Letter No. 124
BY-CRE-01960

Project: I-405, Brickyard to SR 527 Improvement Project
Contract No: 009727

Subject: Vault NW12 – Potential Change
Reference:

PLAN VIEW - NW-12

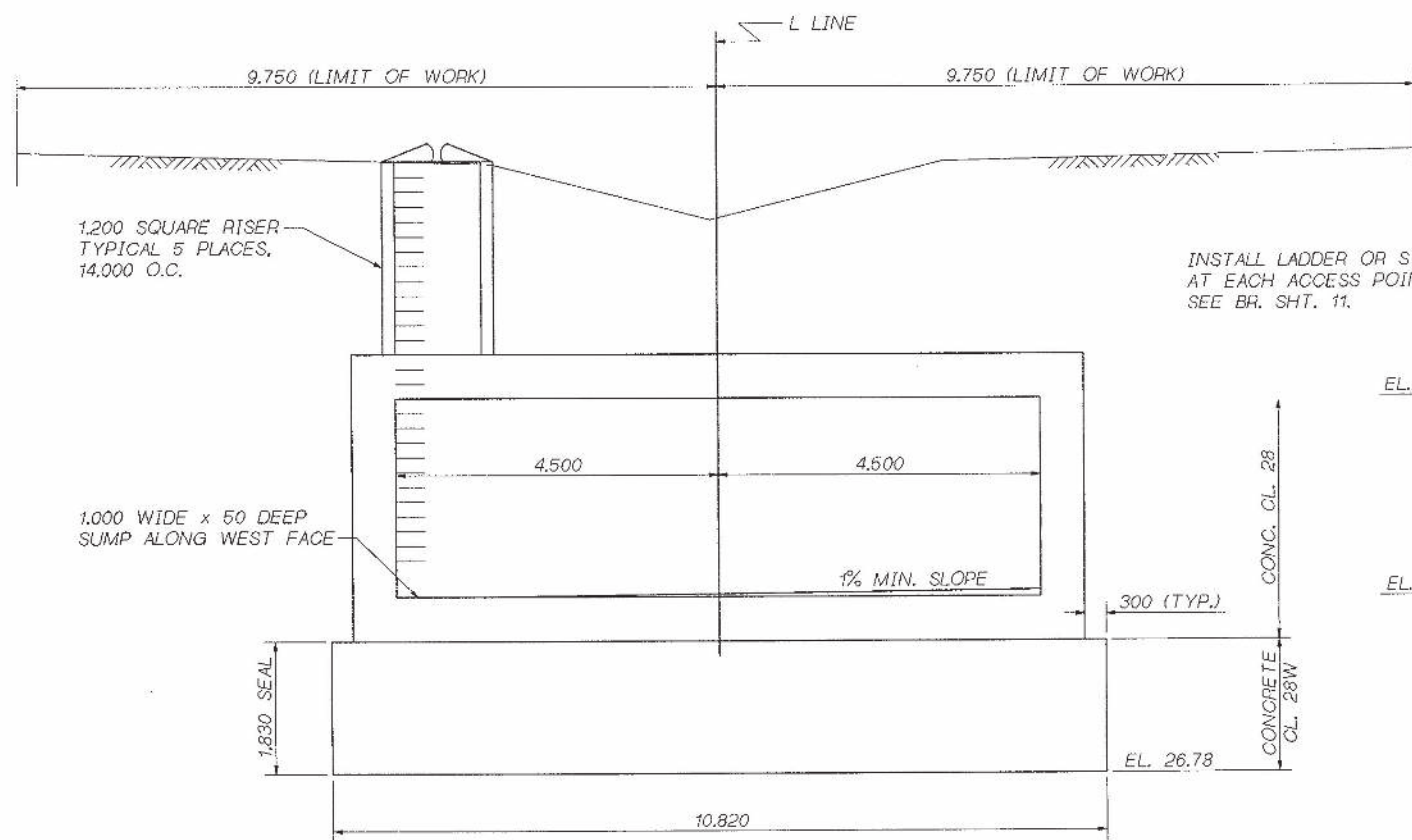
During a field inspection of Vault NW12, it was observed that the vault is significantly larger than what was represented in the RFP documents. Please see attached for reference. Skanska is in the process of cleaning the vault to prepare it for inspection as part of Segment 3 drainage system evaluation efforts. Skanska will also survey the vault for interior dimensioning.
